ADDENDUM NO. 1

City of Mercer Island, Washington Island Crest Way Crosswalk Improvements PROJECT NUMBER SP0135

DATE OF ADDENDUM ISSUE: April 9, 2024
DATE OF BID OPENING: April 11, 2024

KPG PROJECT No. 9MER010600 SHT 10 OF 33

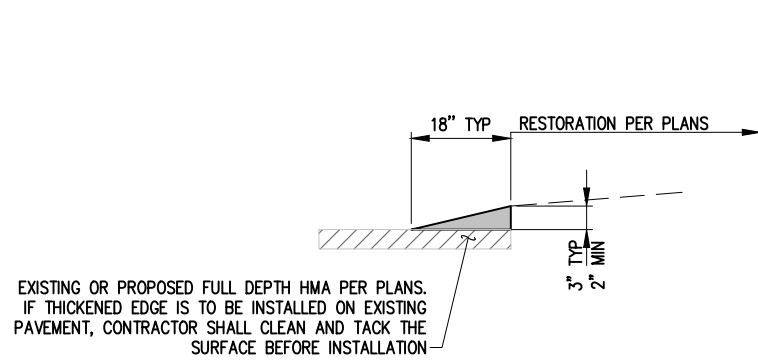
- Page 10: Revision to Construction Note 26.
- Page 14: Added general Fence Detail.
- Pages 19-21: Revisions to Channelization notes 3 & 7. Raised Pavement Markers and Traffic Arrows.

NO.	DATE	BY	APPR.	REVISIONS
1	4/24	BMC	BMC	CONSTRUCTION NOTE 26

- 26 CONSTRUCT NEW 6' TALL WOOD FENCE.
- 28 ADJUST TO GRADE AND INSTALL SOLID LID COVER.

WOOD FENCE DETAIL
SCALE: NTS

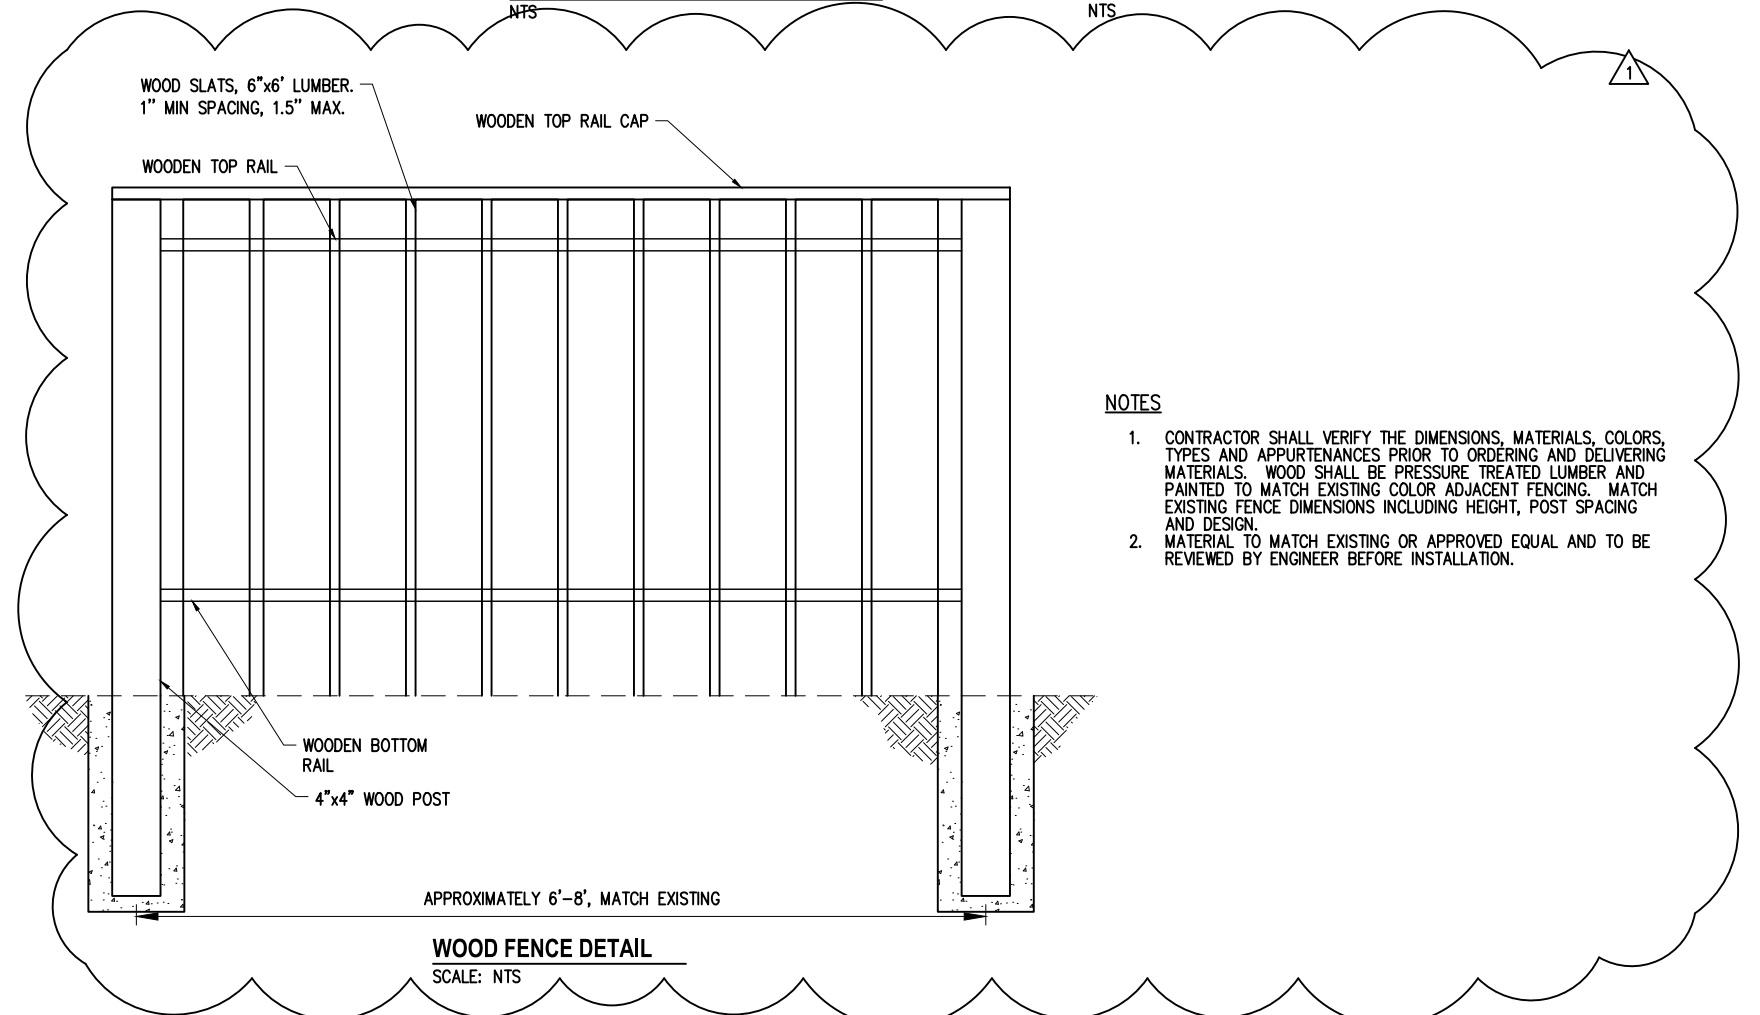
NO.	DATE	BY	APPR.	REVISIONS
1	4/24	BMC	BMC	WOOD FENCE DETAIL

- NOTES**
- CONTRACTOR SHALL VERIFY THE DIMENSIONS, MATERIALS, COLORS, TYPES AND APPURTENANCES PRIOR TO ORDERING AND DELIVERING MATERIALS. WOOD SHALL BE PRESSURE TREATED LUMBER AND PAINTED TO MATCH EXISTING COLOR ADJACENT FENCING. MATCH EXISTING FENCE DIMENSIONS INCLUDING HEIGHT, POST SPACING AND DESIGN.
 - MATERIAL TO MATCH EXISTING OR APPROVED EQUAL AND TO BE REVIEWED BY ENGINEER BEFORE INSTALLATION.

**CHANNELIZATION & SIGNING PLAN
SE 63RD ST**

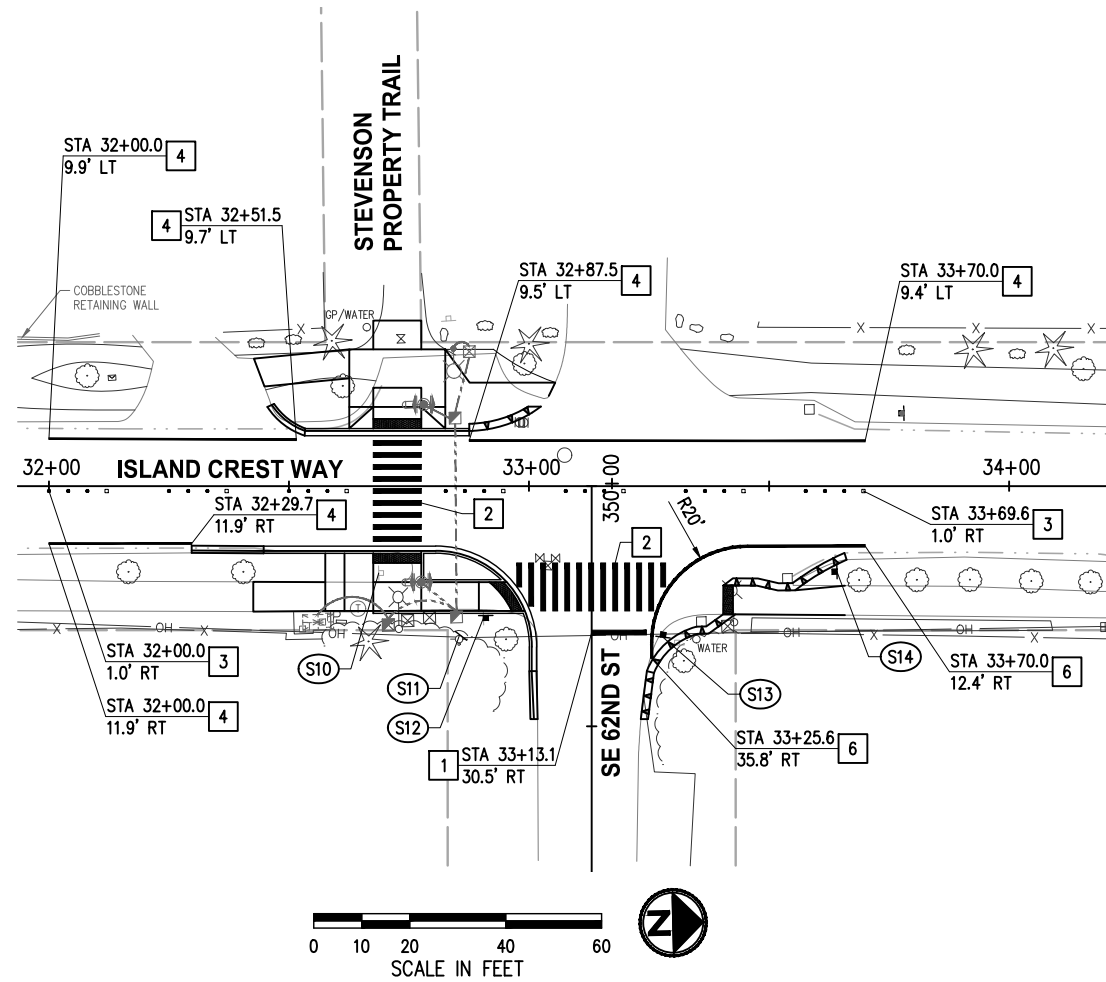
NO.	DATE	BY	APPR.	REVISIONS
1	4/24	BMC	BMC	NOTE REVISION

1. INSTALL THERMOPLASTIC STOP BAR PER DETAIL, SHEET 22.
2. INSTALL THERMOPLASTIC CROSSWALK PER DETAIL, SHEET 22.
3. INSTALL RAISED PAVEMENT MARKERS (RPMS) PER COMI TR-7A.
4. INSTALL 4" WIDE, WHITE PAINT LINE.
5. INSTALL 4" WIDE, YELLOW PAINT LINE PER DETAIL, SHEET 22.

KPG PROJECT No. 9MER010600 SHT 21 OF 33

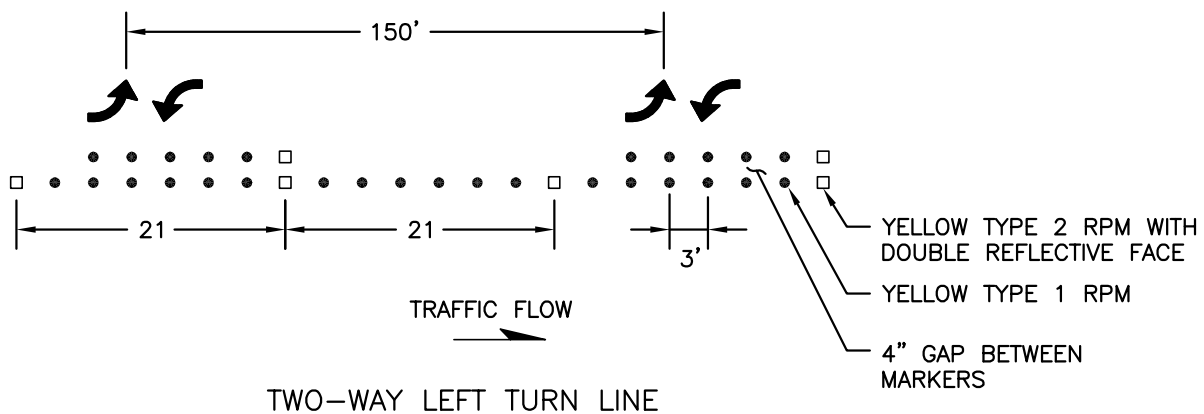
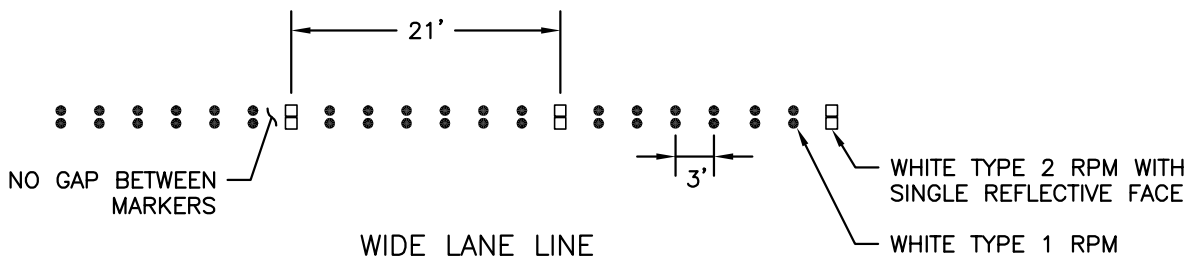
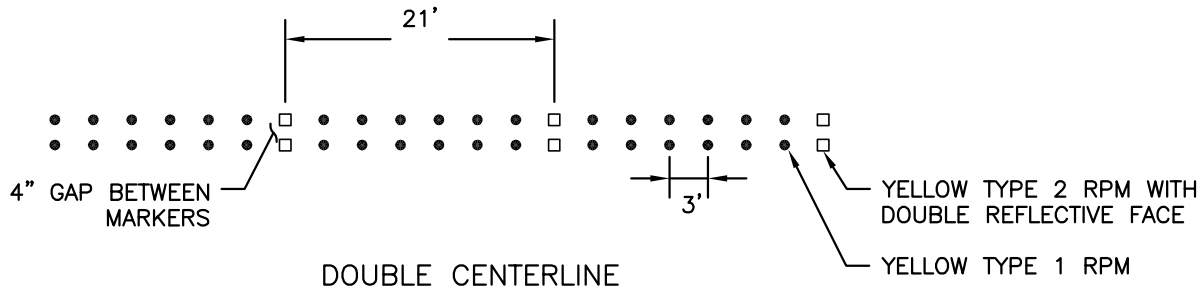
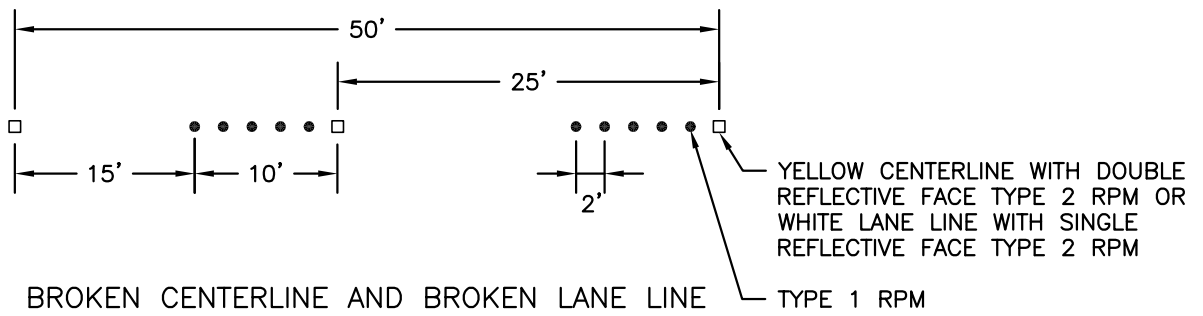
NO.	DATE	BY	APPR.	REVISIONS
1	4/24	BMC	BMC	NOTE REVISION

1. INSTALL THERMOPLASTIC STOP BAR PER DETAIL, SHEET 22.
2. INSTALL THERMOPLASTIC CROSSWALK PER DETAIL, SHEET 22.
3. INSTALL RAISED PAVEMENT MARKERS (RPMS) PER COMI TR-7A.
4. INSTALL 4" WIDE, WHITE PAINT LINE.
7. PLASTIC TRAFFIC ARROW PER COMI TR-7D.
8. INSTALL RAISED PAVEMENT MARKERS (RPMS) PER DETAIL, SHEET 22.
